ATTACHMENT 'A' TO AEP:NRC:00109

PROPOSED REVISIONS TO THE  
DONALD C. COOK NUCLEAR PLANT UNIT NO. 1  
APPENDIX 'A' TECHNICAL SPECIFICATIONS

Figure B 3/4 2-1 TYPICAL INDICATED AXIAL FLUX DIFFERENCE VERSUS  
THERMAL POWER AT BOL

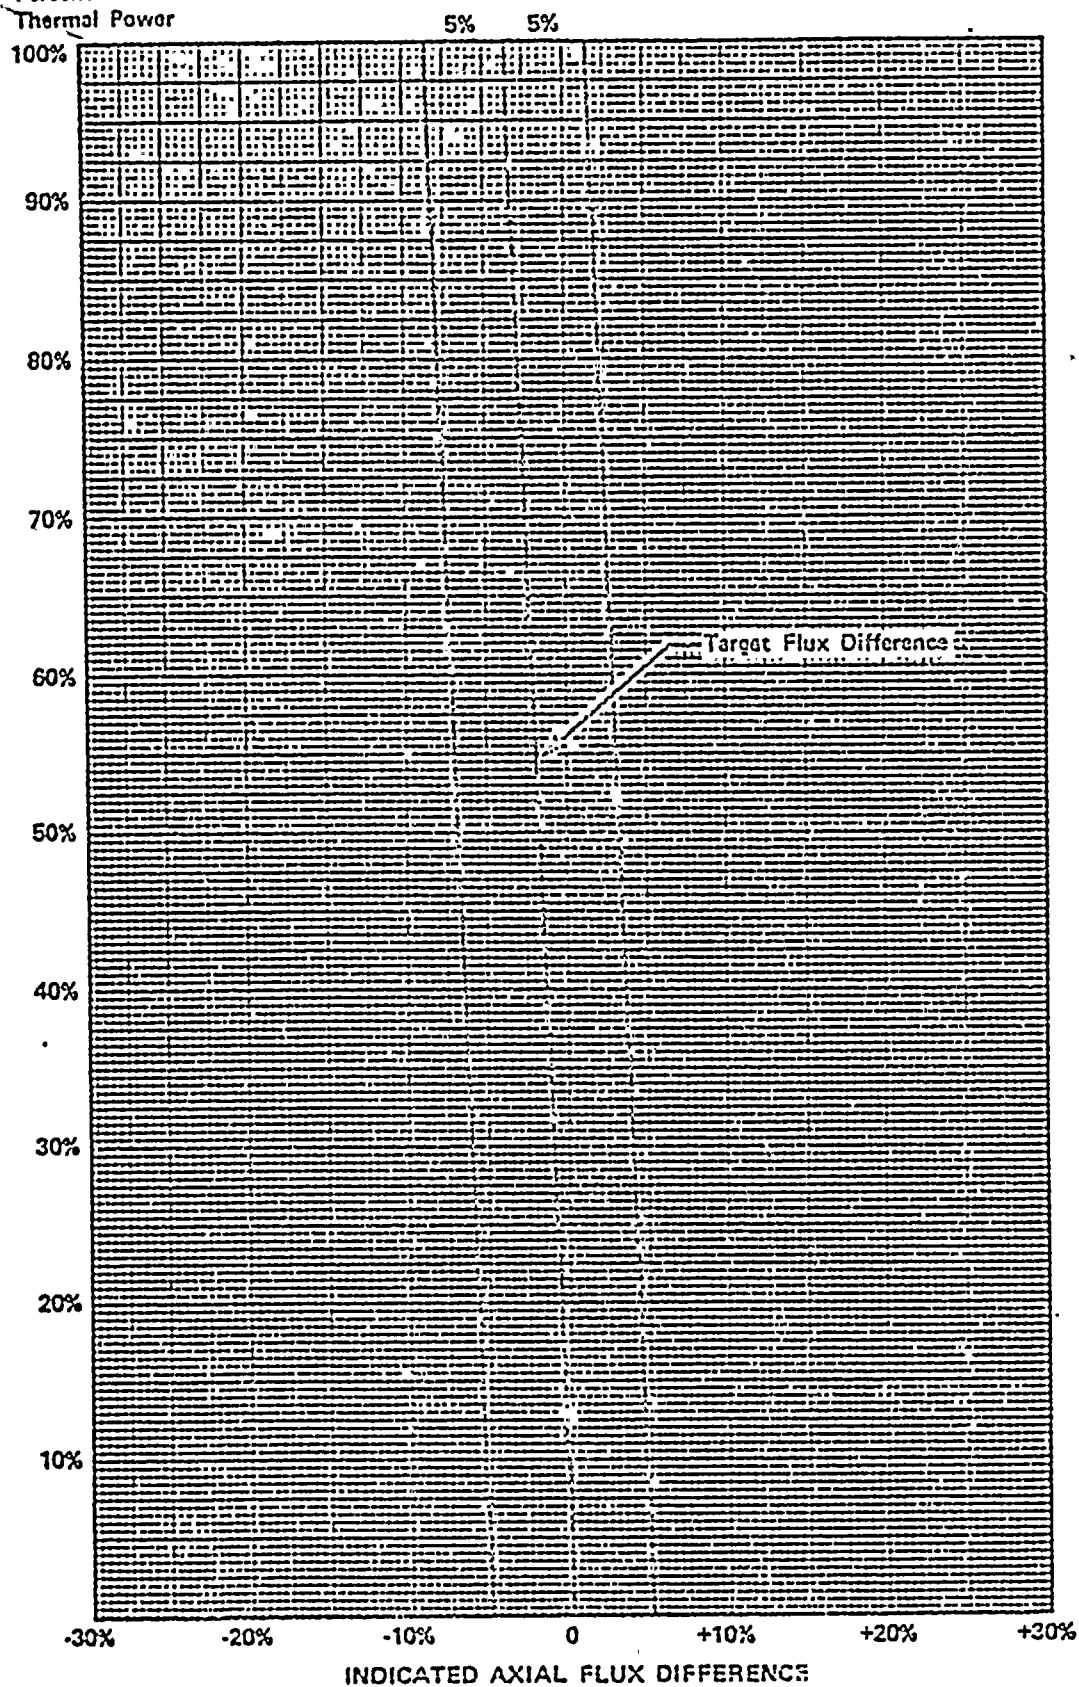
This change involves a revision to Bases section 3/4 2.2 on page B3/4 2-4. In paragraph a. the word "rod" should be changed to "rods" as shown in the attached revised page B3/4 2-4. This change is editorial. This change will not adversely affect the health and safety of the public.

FIGURE 6.2-2 Facility Organization - Donald C. Cook - Unit No. 1

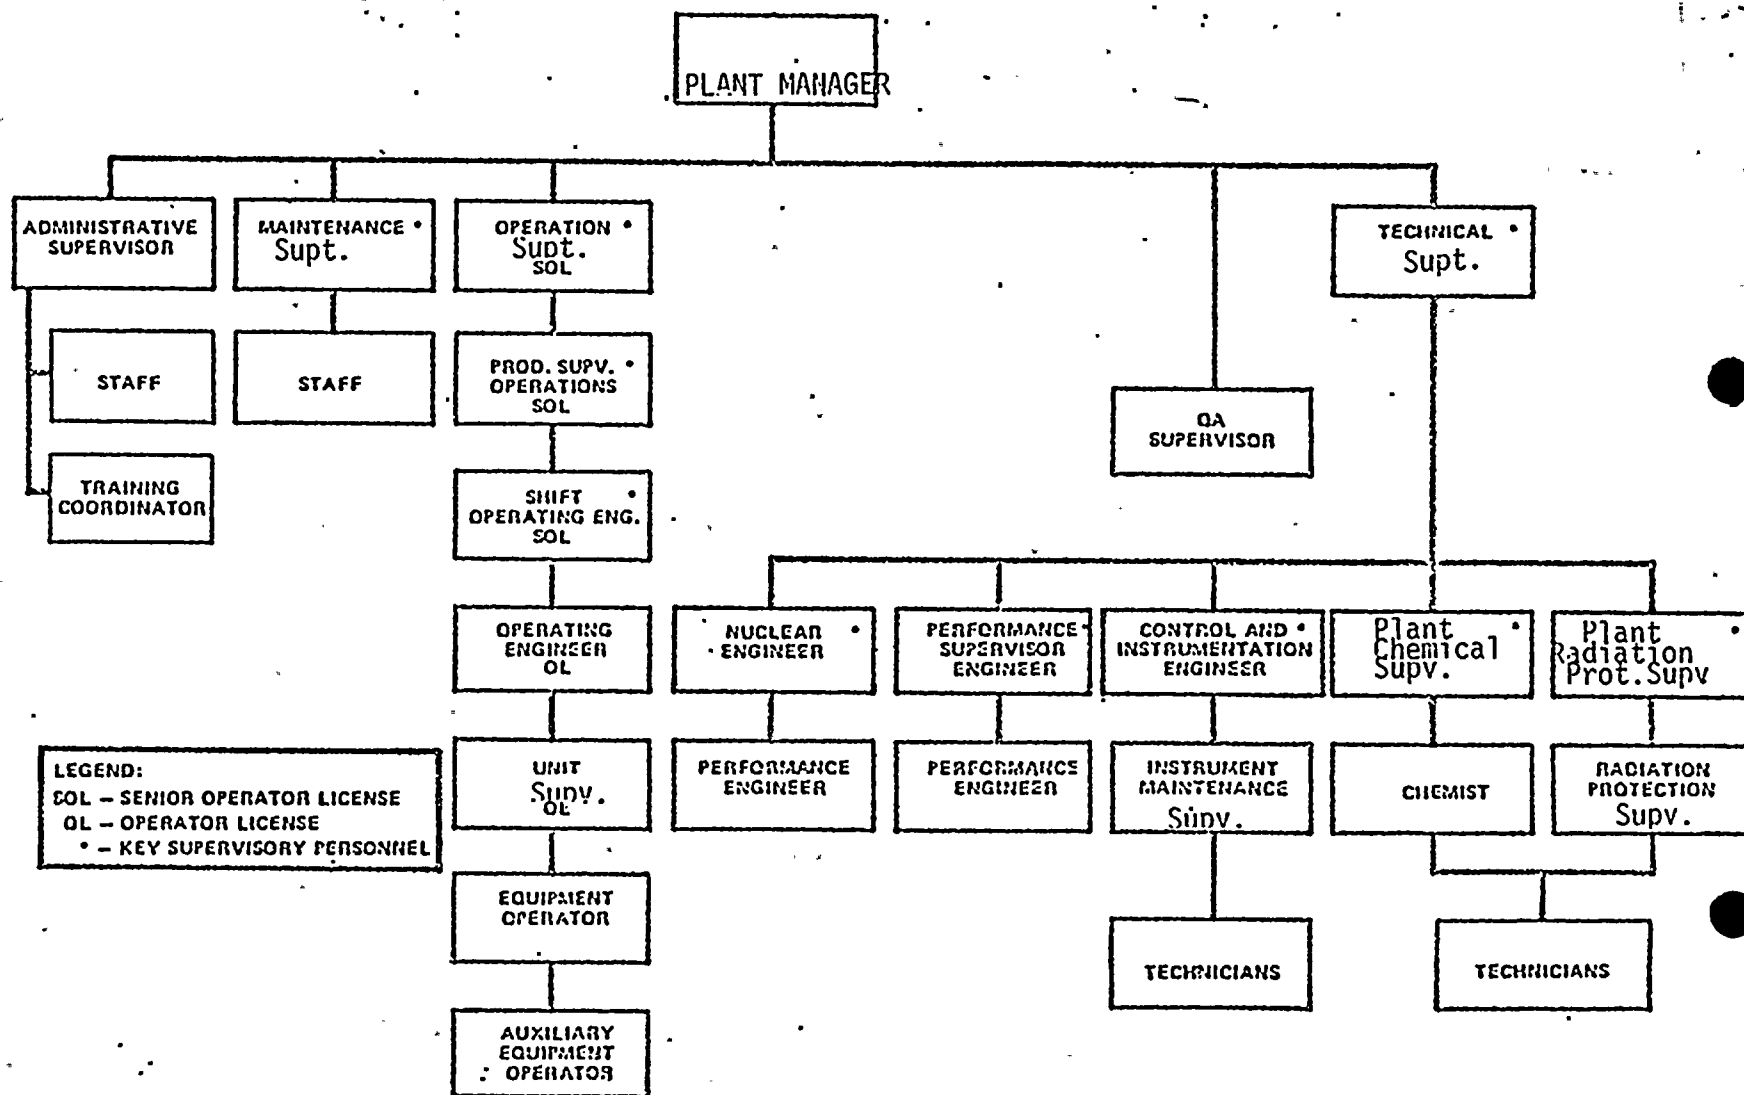
This change involves a revision to Figure 6.2-2 "Facility Organization" on page 6-3. We have had a system wide change in the titles of the staff members of our operating plant. Certain "Foreman" are now "Supervisors" and "Supervisors" are now "Superintendents." This change affects the Technical Specifications for the Cook Nuclear Plant as shown in the attached revised pages 6-3 and 6-4.
